COMMENTS ON RESPONSES TO EXQ1 DEADLINE 2

BY ANNE HEARD (Interested Party Reference 20054475)

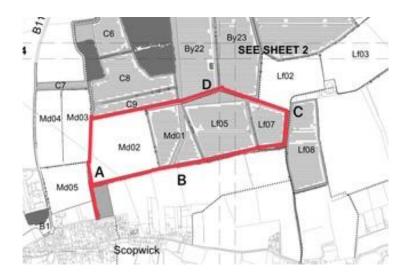
26. The Applicant then goes on to suggest that users of the PRoW would be likely to experience noise levels above the ambient "for a matter of minutes". In an attempt to demonstrate that the Applicant has understated the magnitude of the likely effect of noise on PRoW users, I set out below details of a walk I took along the public footpaths around Scopwick on a rainy cold February day this year. The route of the walk is shown with a red line on the plan below:-

27. I walked north along Scop/10/1, then turned east along Scop/10/2, then north along Scop/11/4, then west along Scop/1135/3 and Scop/1135/3 and finally south along Scop/737/1, a walk of approximately 2.5 km which took me an hour as I stopped to take photographs. The points marked A,B, C and D on the plan are points from where I took photos as follows:-

- 28. This route is well used, the track is worn (Photo at Point B) with evidence of use by people and horse riders. Whilst I was there during an early afternoon on a weekday in winter I met two groups of dog walkers. The fact of frequent use is borne out by the footfall evidence of the Stepping Out walks submitted by NKDC in their response to EXQ1 (REP1-103-Q1.12.3). This shows that during 2024/5 4903 people walked the Scopwick footpaths and 7205 walked the Blankney footpaths.
- 29. There are no built features which would attenuate any noise from plant and machinery along these footpaths, so any noise emitted from construction or operational activities would be heard over long distances and for longer than the "few minutes" described by the Applicant.
